**Municipal Services Center, Council Chamber
3600 Tremont Road**

BZAP Meeting Date: February 4, 2026

Subject: 2490 Wickliffe Road (VAR-10-26) - To allow the construction of a new single-family residence that does not meet residential design standards. [Postponed from January 21, 2026 BZAP hearing.]

Subject: 1694 Essex Road (VAR-12-26) - To allow a two-story addition and garage which results in two variances: a 7.34 inch encroachment into the side yard longwall setback where an 11.34-inch setback is required, and projects into the rear yard profile. [Postponed from January 21, 2026 BZAP hearing.]

DRAWING TITLE:
OVERALL LAYOUT PLAN

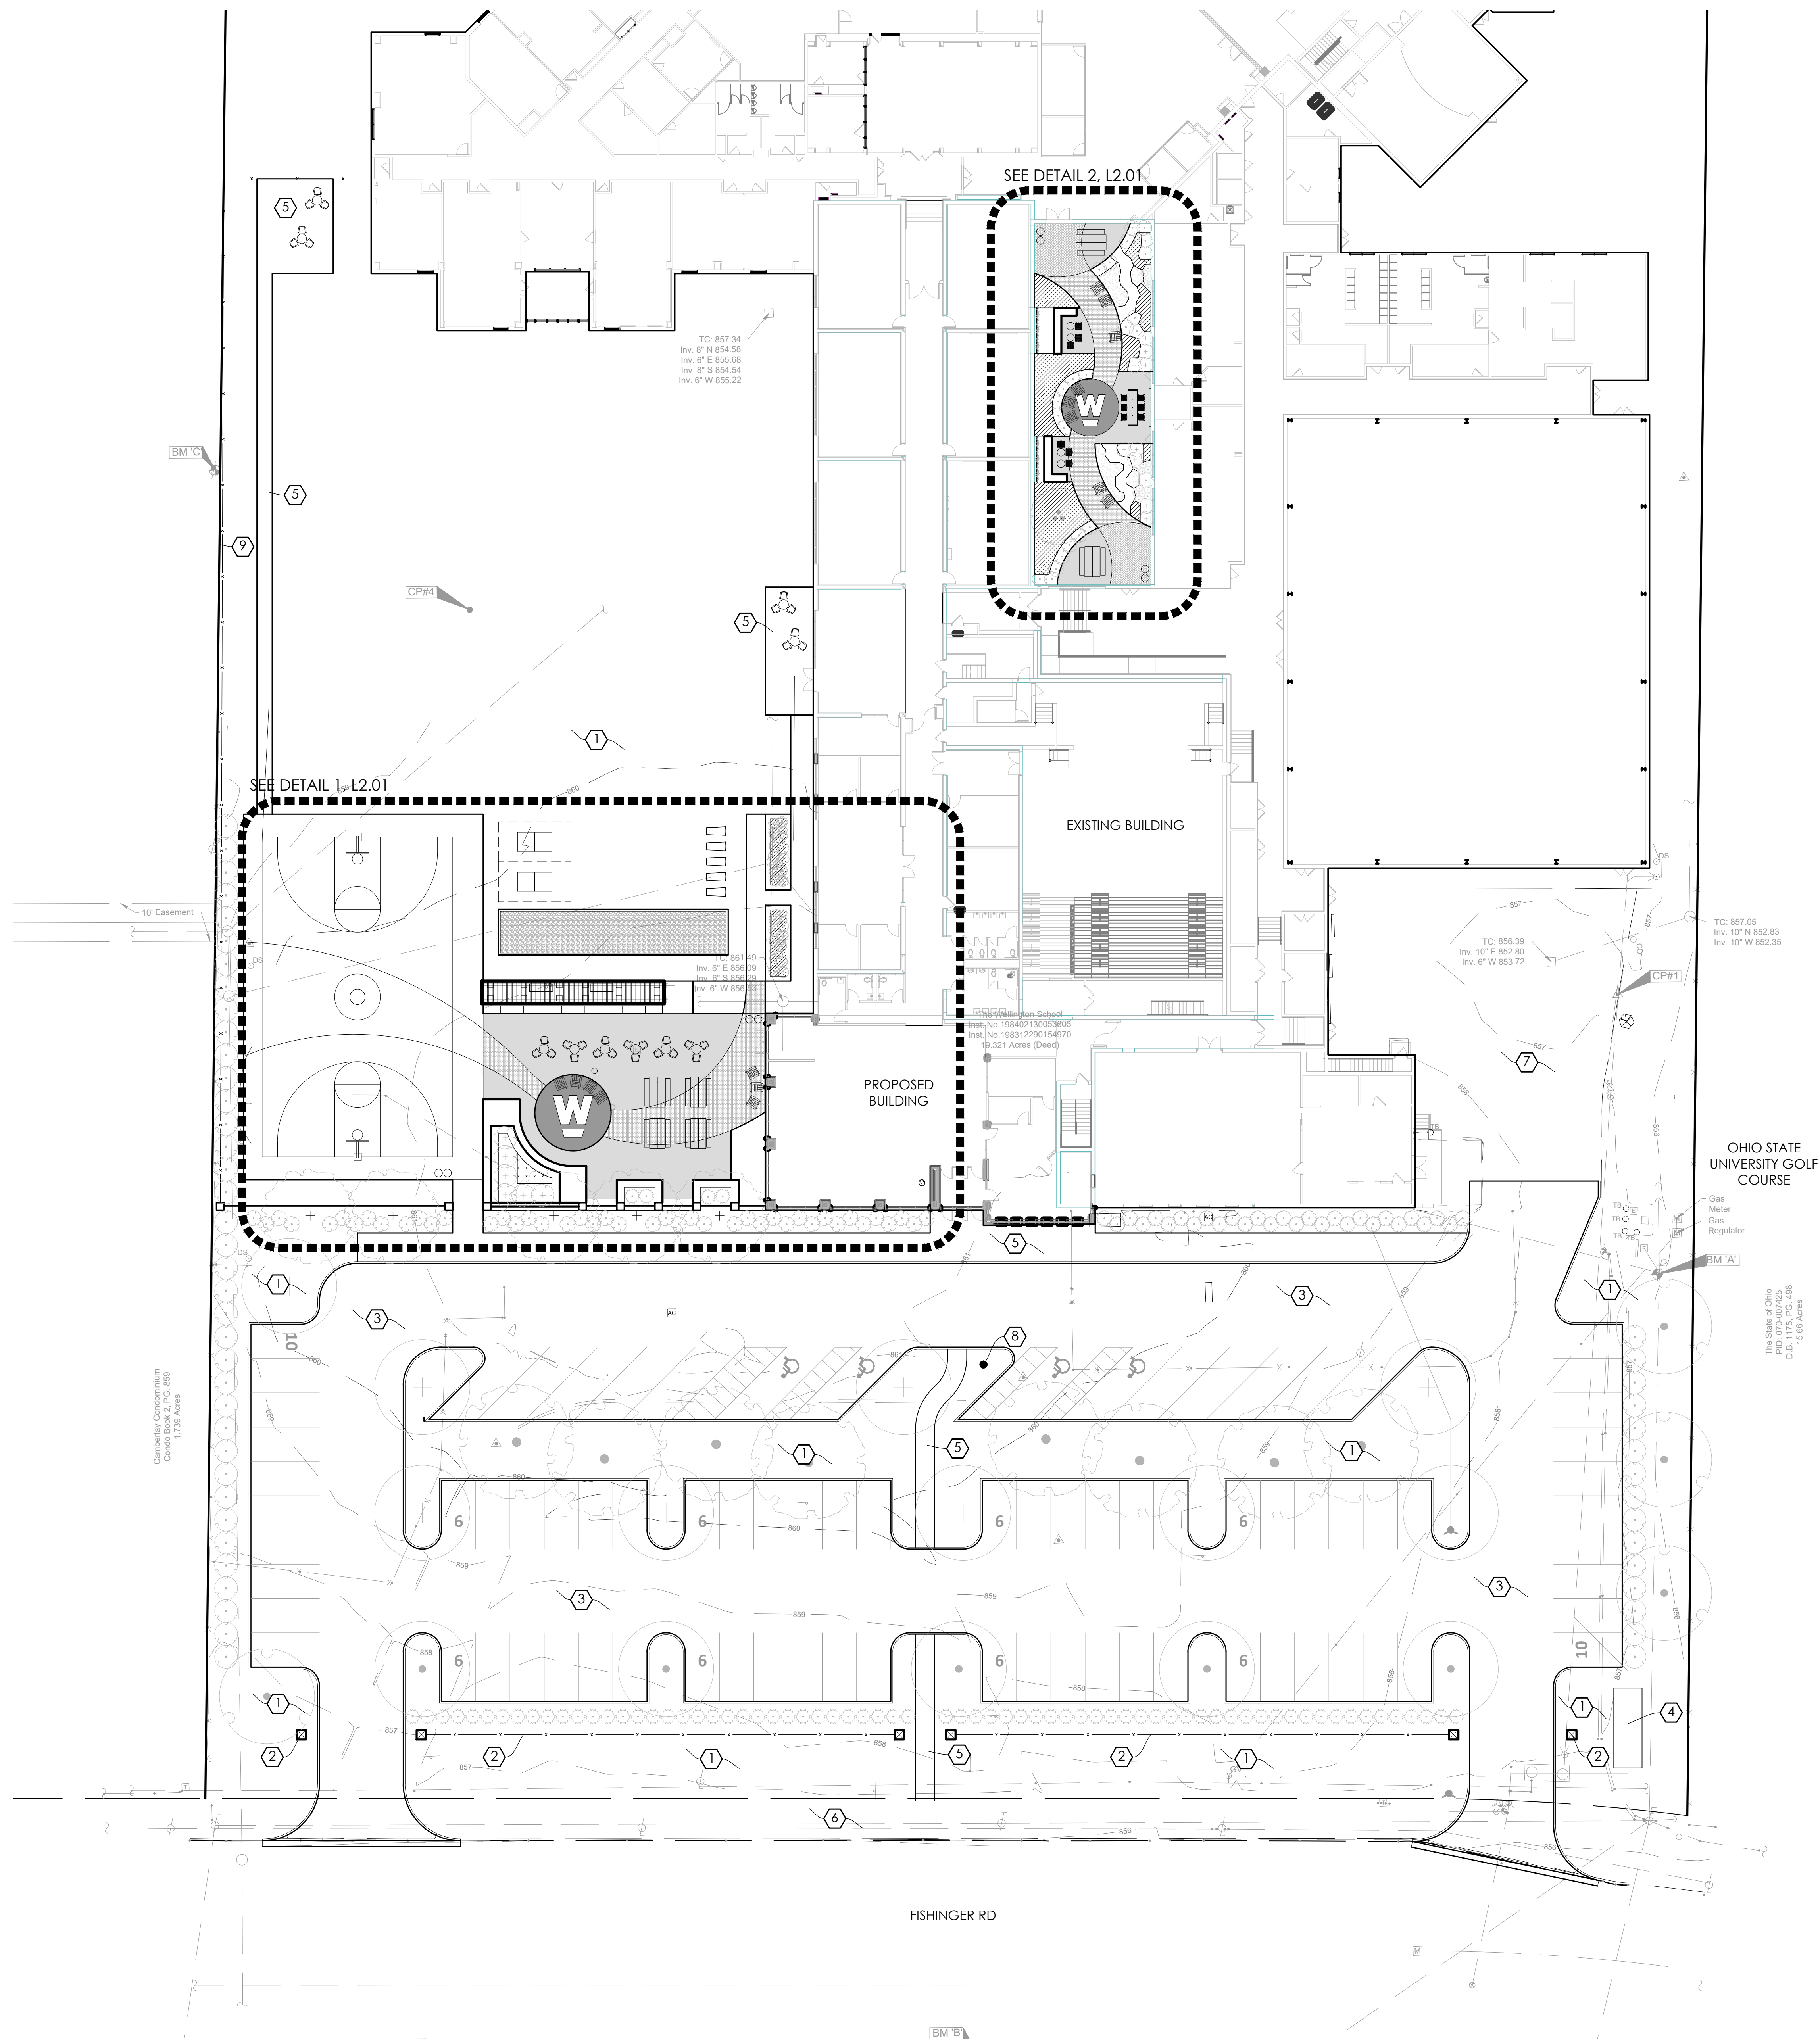
- An access analysis for the two Fishinger Road entrances is required;
- Add an accessible ramp for ADA parking on the north side of the parking lot, near the new Upper School entrance; and
- Pavement cuts to Fishinger Road are not permitted until 2028; please work with the City Engineer on alternative options.

- Consider bike/pedestrian connections to/from Fishinger Road. Perhaps move the proposed north-south sidewalk to the west side so that the path does not cross the parking lot. Add a bike rack near the entrance; and
